ADDENDUM NO. 002

RE: Water System Capital Improvements – Phase II
For Town of Bluefield
T&L Project No. 16176

DATE: June 8, 2023

E103

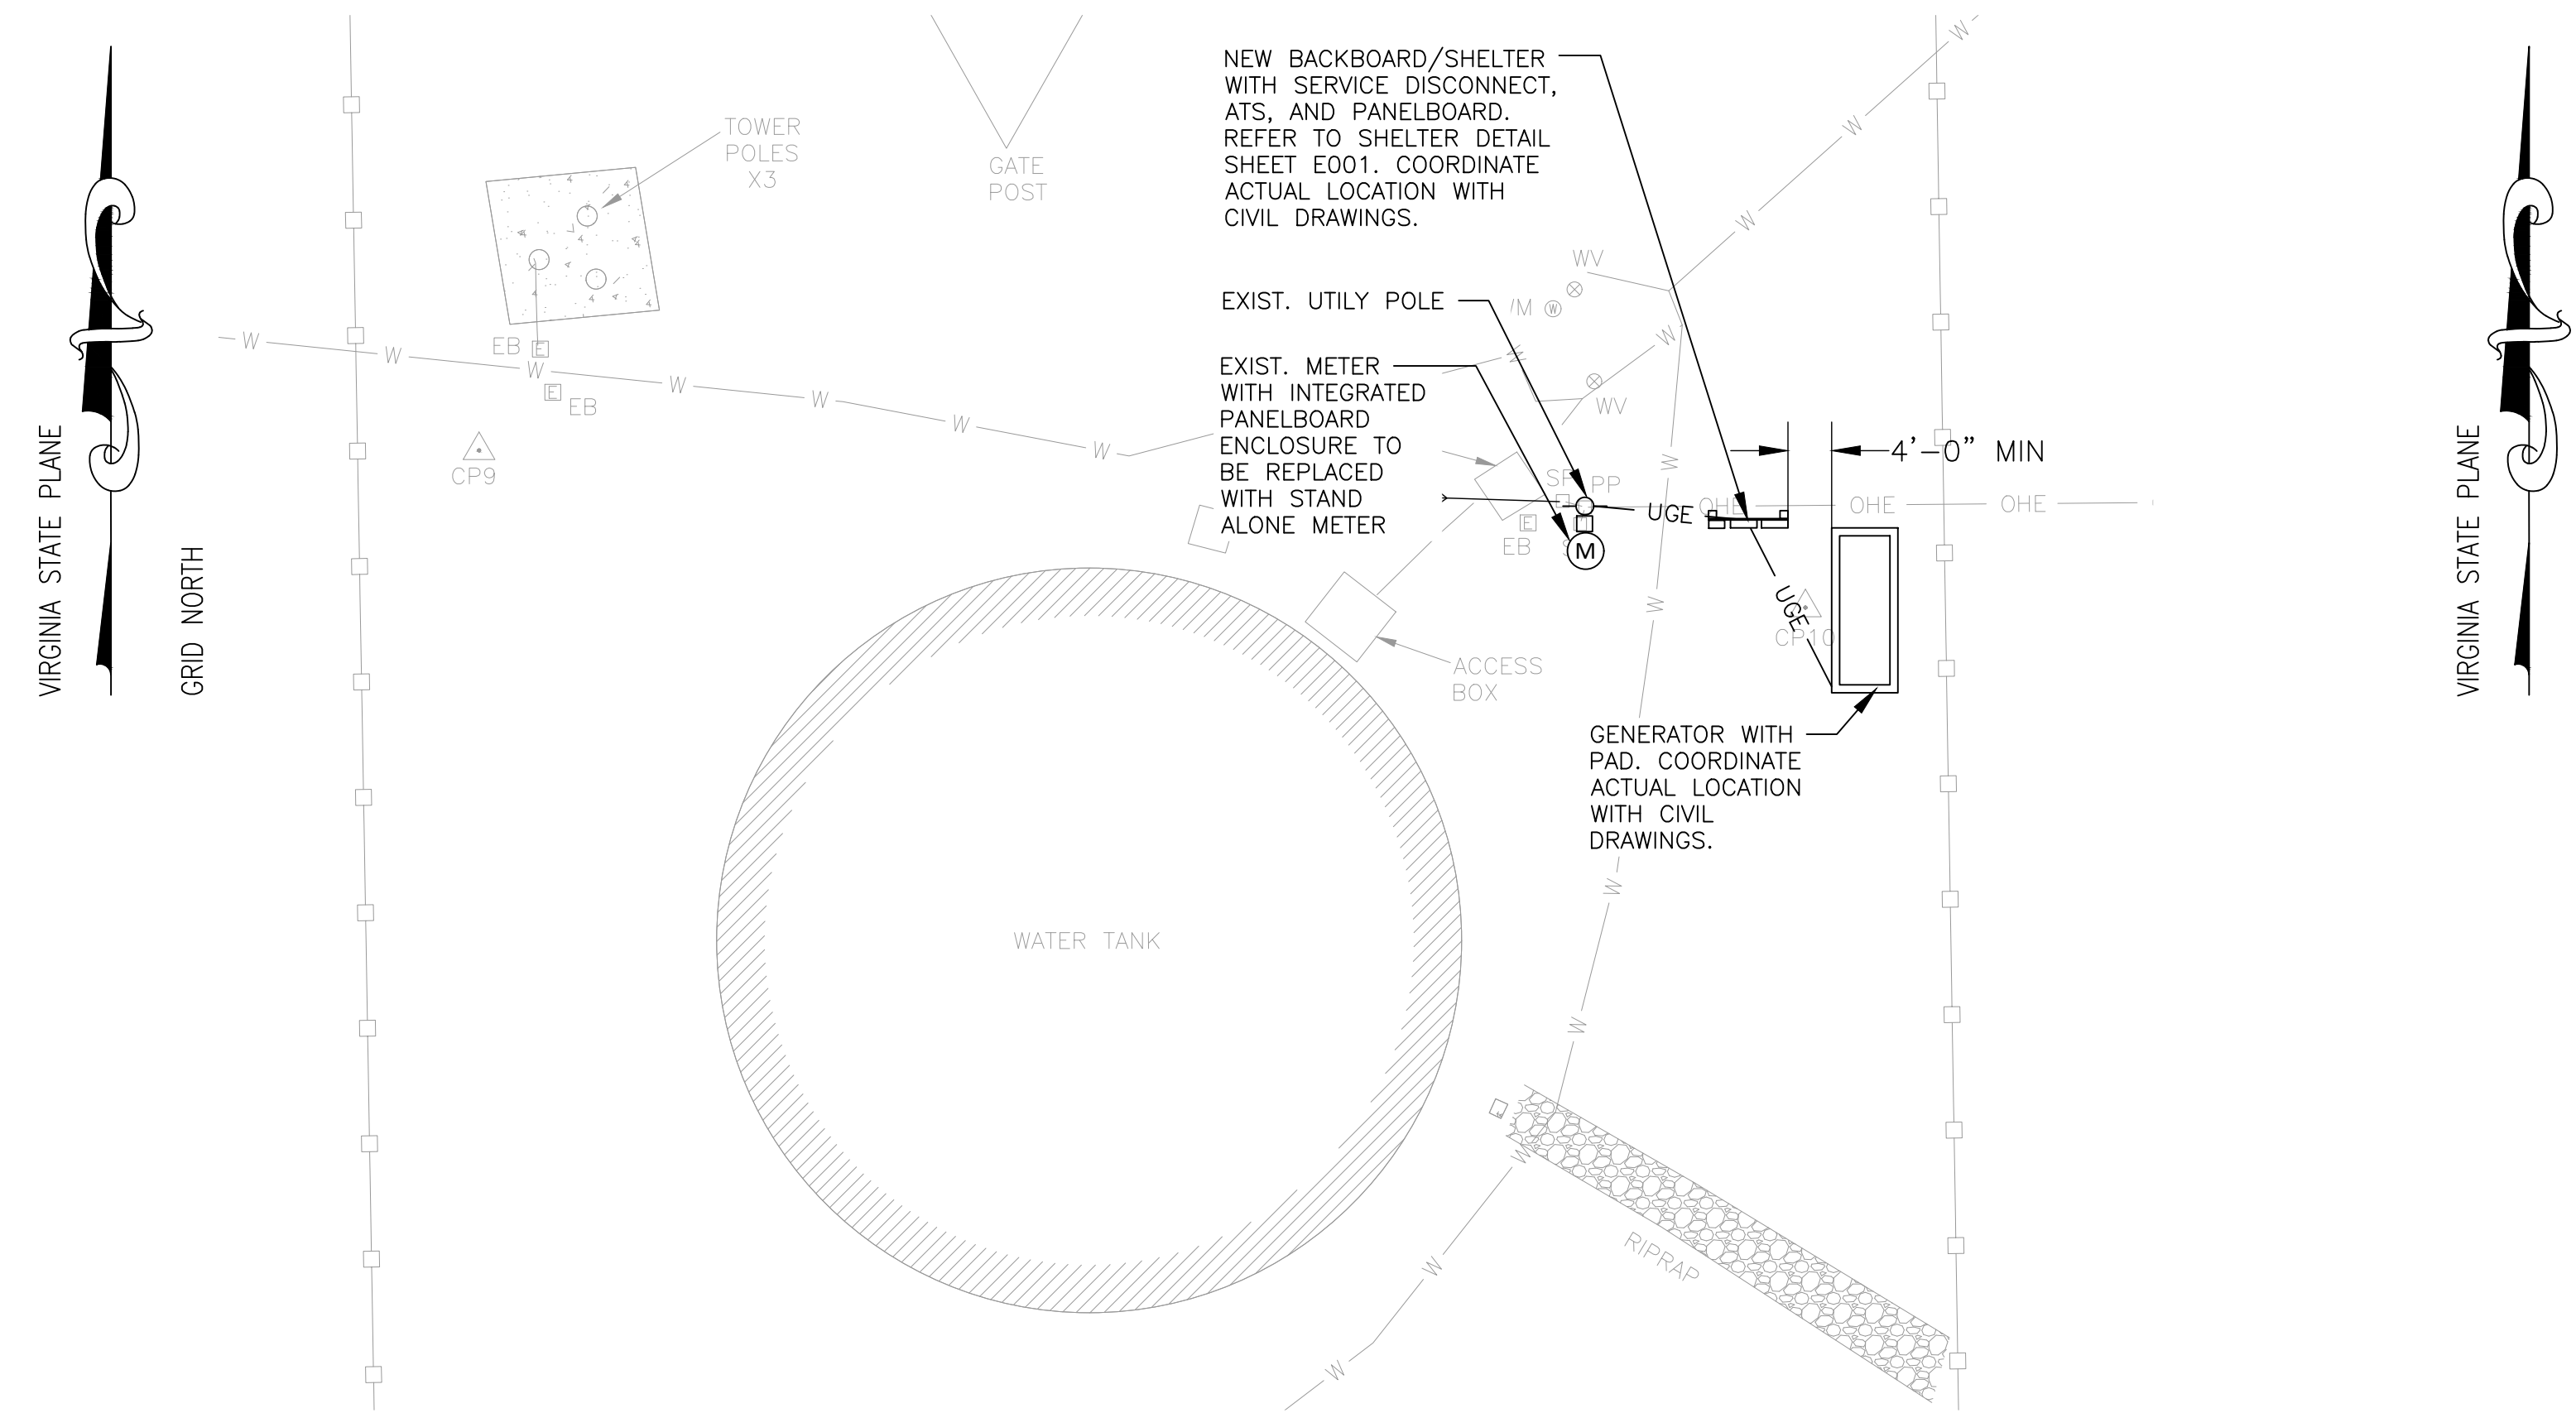
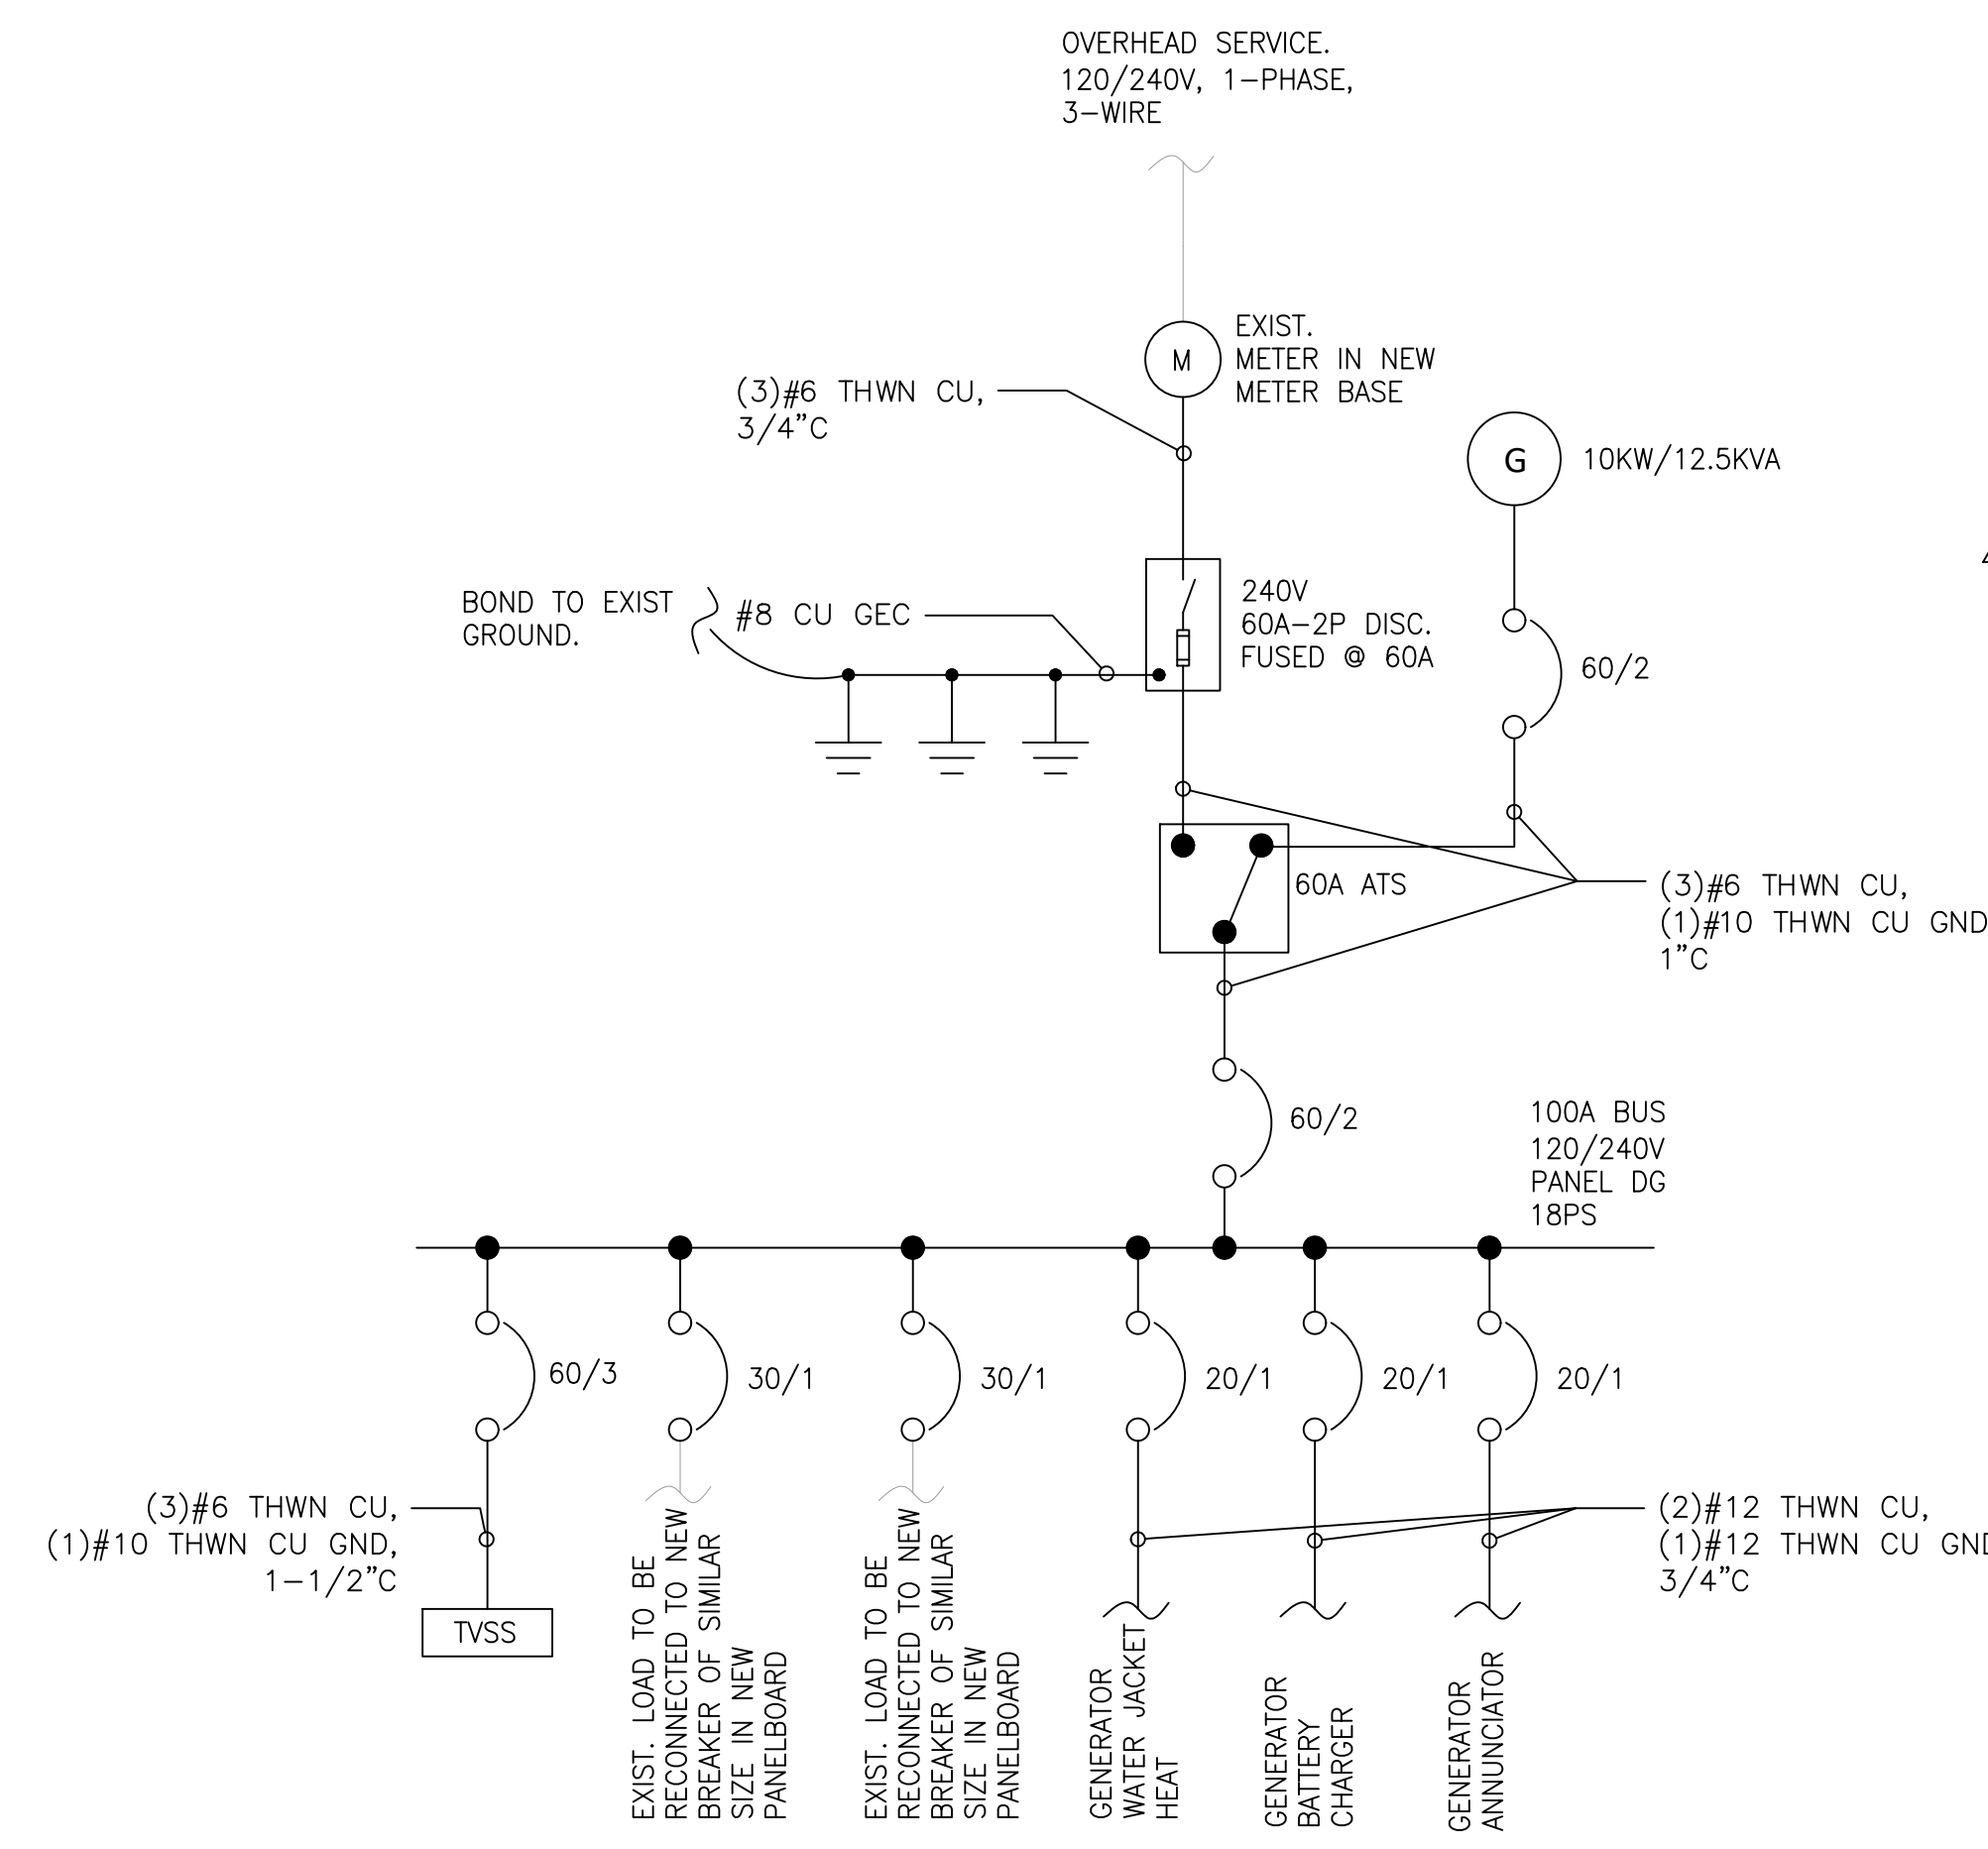
1. All new camera systems shall be on separate networks from the main station controls.
2. The 0.8PF stated on Risers E102 and E103 applies to both single or three-phase power.
3. The remote is to provide access on the exterior of the generator enclosure such that fuel is not spilled inside of the generator enclosure. Fuel fill shall be lockable.
4. Pipe material for lines between the basin and outfall shall be ductile iron as specified in Specification Section 33 1116 – Water Utility Distribution and Treatment Piping and Valves.

1. Drawing C103 has been revised to add new 12' wide double swing gates to the existing fencing between the park and the water treatment plan and add hatching to delineate the area adjacent to the basins where additional earthwork shall be performed to satisfy flood mitigation requirements. The revised drawing is enclosed.
2. Drawing C201 has been revised to add clarification for the ornamental aluminum fencing. The revised drawing is enclosed.
3. Drawing C207 has been revised to clarify the motor requirements for the Raw Water Pump. The revised drawing is enclosed.
4. Drawing E101 has been revised to shift text for visibility. The revised drawing is enclosed.
5. Drawings E102 and E103:
 - a. Additional information has been provided in regards to startup requirements.
 - b. Each ATS withstand requirement value based off of given fault current has been corrected.

- EXISTING GROUND ELECTRODE CONDUCTOR MAY BE REUSED IF CONDUCTOR CAN BE TRANSFERRED WITHOUT SPLICING AND IS SIZED AS INDICATED.
 - THE MAXIMUM AVAILABLE FAULT CURRENT FOR DOUBLE GATES TANK IS 1088A. ALL INSTALLED EQUIPMENT MUST MEET OR EXCEED THIS RATING. PROVIDE LABEL FOR NEW SERVICE DISCONNECT IN ACCORDANCE WITH THE NEC 110.24 'AVAILABLE FAULT CURRENT 1088AMPS, 02/21/2023.'

- THE MAXIMUM AVAILABLE FAULT CURRENT FOR FALLS MILL IS 1493A. ALL INSTALLED EQUIPMENT MUST MEET OR EXCEED THIS RATING. PROVIDE LABEL FOR NEW SERVICE DISCONNECT IN ACCORDANCE WITH THE NEC 110.24 'AVAILABLE FAULT CURRENT 1493AMPS, 02/21/2023.'
